Subject: Response to Request for Review –Aços Villares Natural gas fuel switch project (1037)

Please find below our responses to the issues raised in the requests for review for this project. The reasons for the requests are shown in shaded boxes, followed by our response.

Figure 1: Monthly efficiency for group of equipment C5bur and M3 along the complete crediting period (including data from the two verifications).

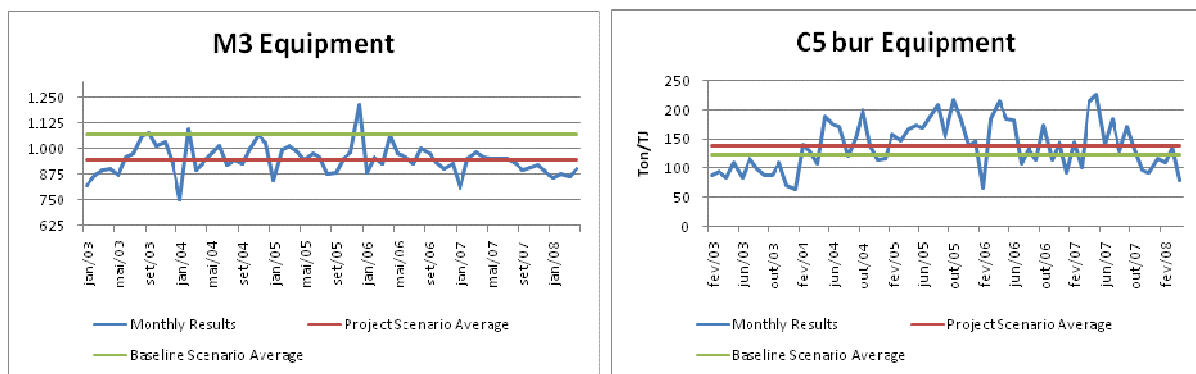
In the project scenario, to achieve equivalent steel output requires much less (around half) energy as compared to baseline scenario. Further clarification is required on how the DOE verified that fuel switching in the project activity does not focus primarily on energy efficiency, as required by this applied methodology AMS-III.B. v10

- 2) In average, the fossil fuel change does not expect to change the efficiency of project activity. The baseline energy consumption was calculated based on an average of values (and not in a single value). The industrial process always presents a random variation² thus some months will be more efficient than the average, and others less efficient. Moreover, the units are actually a couple of equipment doing the same process, what can increase the instantaneous variation, but do not affect significantly the average operation of this process. Please see an example in the graph below of an equipment of this project.³

As conclusion, sometimes, the energy efficiency of a unit may appear higher or lower than the baseline number, but it is result from random variation, and gains in energy efficiency were not expected, even if allowed by the methodology. If there is a gain, the example above shows that is small, and thus not the main driving force of the project.
